RE: Amended Appeal Application and Request for Site Plan Waiver

**Block 1314, Lots 38, 39 and 40
1165 Haddon Avenue, 1167 Haddon Avenue, and adjoining vacant parcel identified as WS
Haddon 120S of Sycamor
Proposed Consolidation for Islam Study Center Mixed-Use Development**

**Re: Use Variance and Site Plan Waiver
Islamic Study Center
1165 Haddon Avenue
Block 1314, Lot 38, 39, & 40
RVE# 04-08-P-1001**

We have reviewed a use variance and site plan waiver request application, consisting of the following:

SHEET NAME:
EXISTING / PROP. PLOT PLANS
C-100

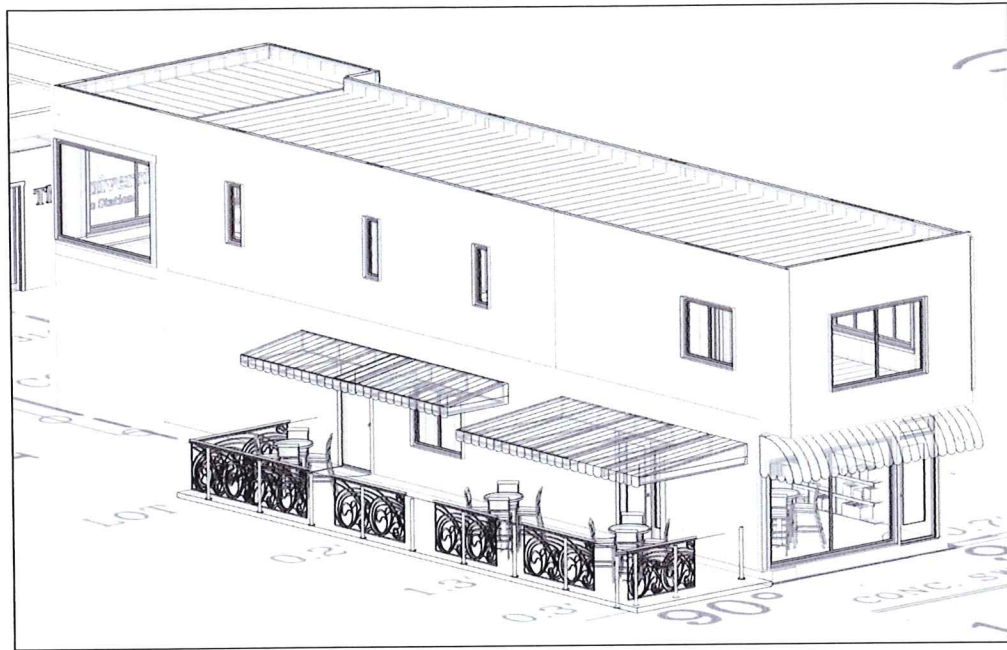
1. The submitted survey is only for Lot 39. The applicant shall provide a survey for Lots 38 and 40 that confirms buildings do not encroach onto property not included as part of this application. Setbacks for existing and proposed improvements should be provided to confirm the requested bulk variances.

2. The three (3) lots are proposed for consolidation. A consolidation plot plan and deed description shall be submitted for formal review. Any consolidation plan will also need to comply with County recording requirements.

3. Per the definition of “accessory use/structure” and per Section 870-23, any accessory structure attached to a principal building by a common wall, an abutting wall or a roof shall be considered part of the principal building and shall adhere to the yard requirements for the principal building. In this case the proposed roof over the patio is attached to the principal building and therefore shall adhere to the setback requirements of the principal building. The side yard setback is 4.75 ft and a variance is necessary.

4. As noted above, the applicant shall provide the building coverage calculation.
5. Our office calculated the lot coverage at approximately 80%. The applicant shall provide a revised plan with exact impervious calculations to confirm a variance is not necessary. If 80% lot coverage is exceeded, pursuant to Section 870-66, a variance will be necessary.

SHEET NAME:
COFFEE SHOP ..
FLOOR PLAN

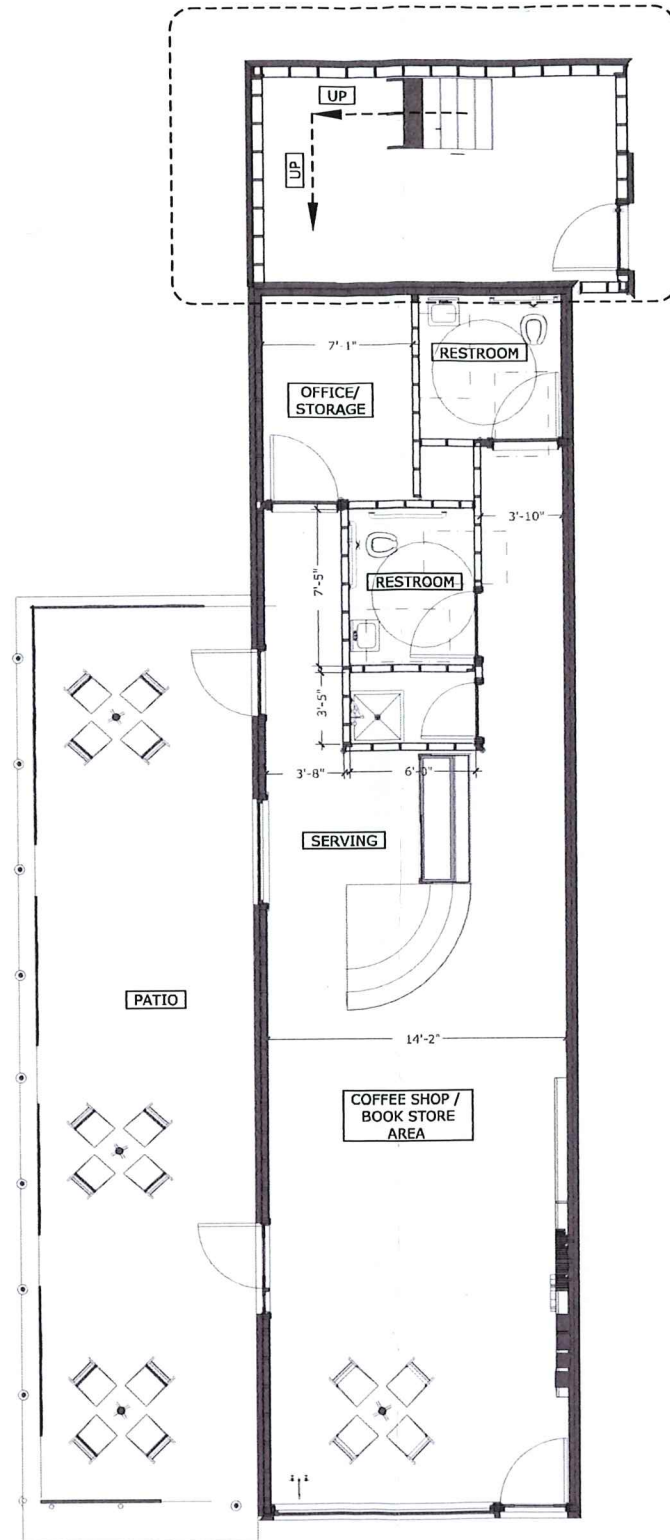
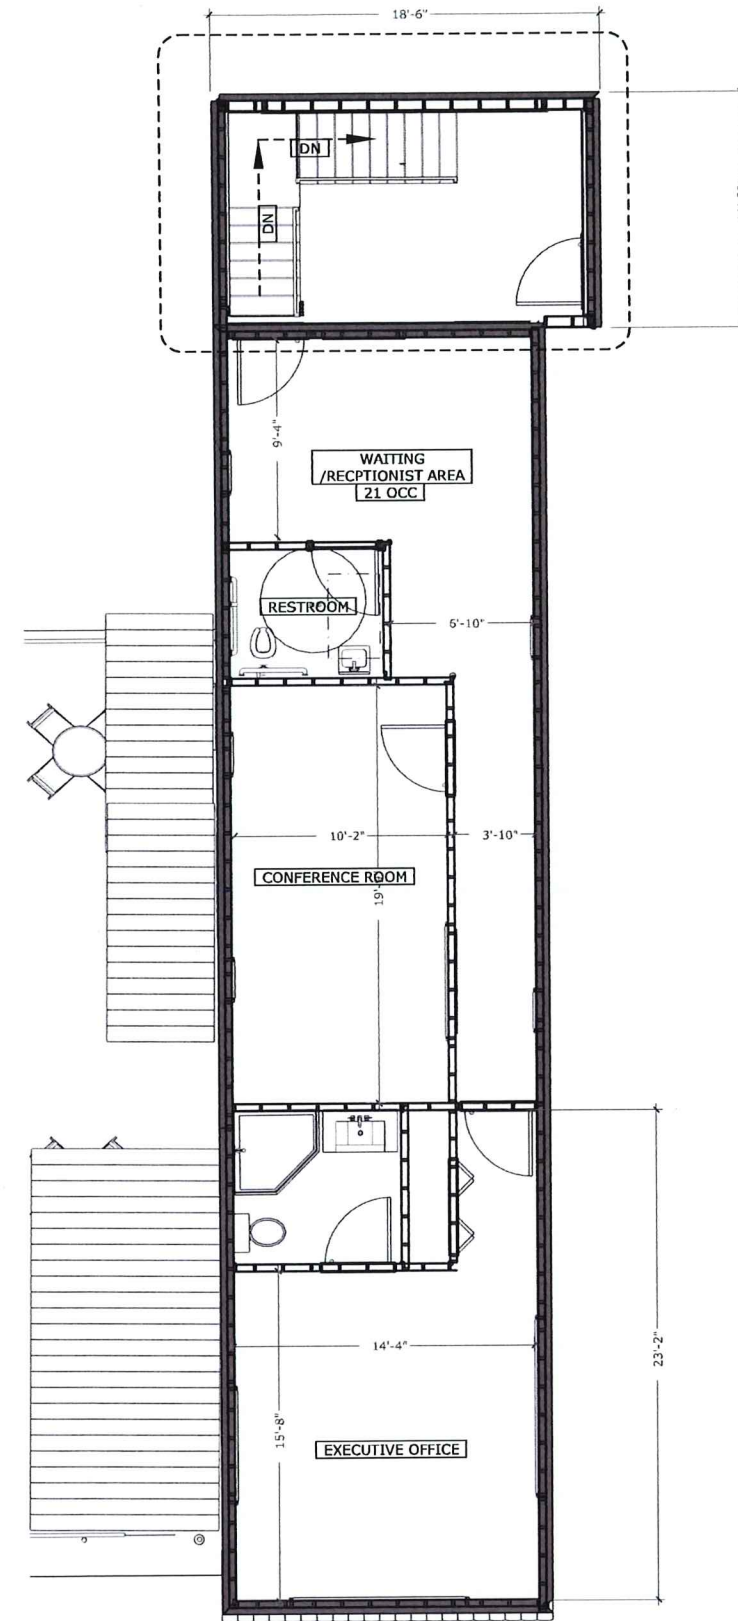
7. The applicant should note that the rear addition was indicated to be 180 s.f. in the application narrative. On the plans, however, the addition is shown to be ±206 s.f. Applicant should provide testimony as to the discrepancy.

10. Elevations should be revised to provide the height of all buildings.
11. Based on the submitted floor plans, while only the rear building addition and outdoor seating were described in the application narrative, it appears that other improvements are proposed including interior renovations, façade improvements, and an addition to the side of the building.

- Furthermore, the front section of the second floor along Haddon Ave, appears to project about 3 ft. past the first-floor building wall. This projection may be encroaching into the public right-of-way. The applicant shall provide a revised plan to demonstrate that there is no encroachment. Testimony should be provided and the applicant should be aware that the Zoning Board does not have jurisdiction over building encroachment into the ROW.

SHEET NAME:
COFFEE SHOP ..
ELEVATIONS

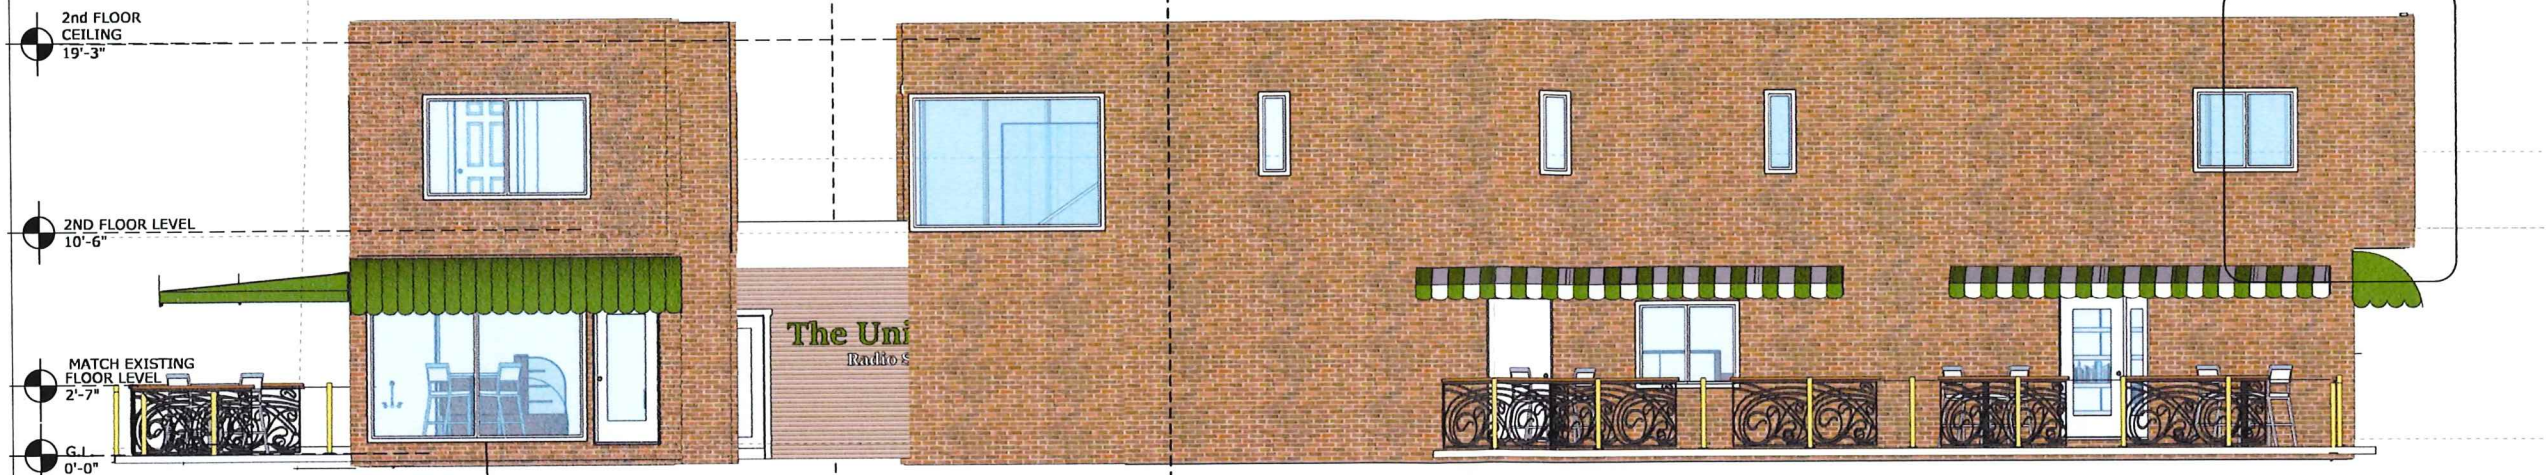
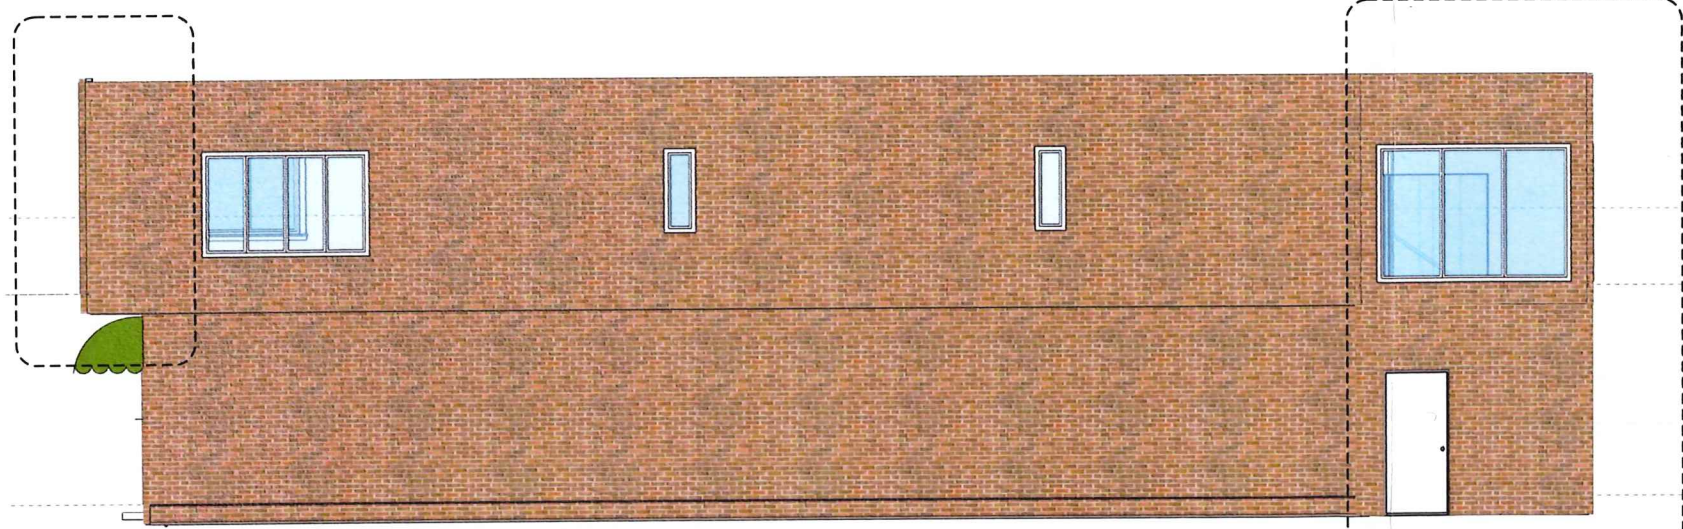
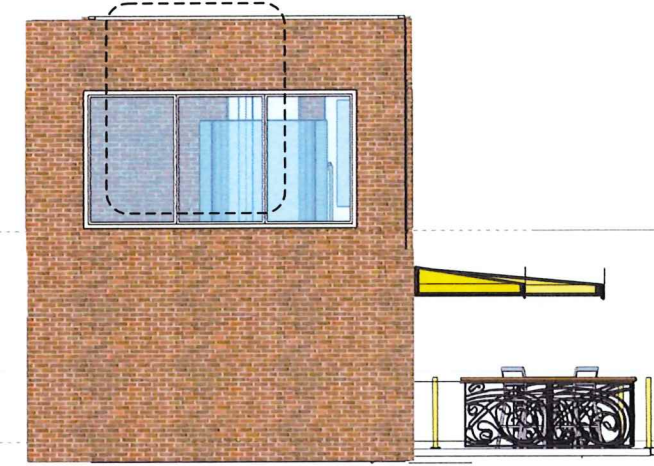
13. Per Section 870-192 and 870-244B, Landscaping shall be provided. Landscaping should be provided where appropriate.
 14. Per the Gateway Redevelopment Plan, all awnings/canopies shall be securely attached to the building so that the lowest part of the awning or canopy is mounted a minimum of 8'- 0" and a maximum of 12'- 0" above the sidewalk at the storefront. It appears that a canopy/awning is proposed over the entrance of the building. Vertical clearance measurements should be provided on the elevations.
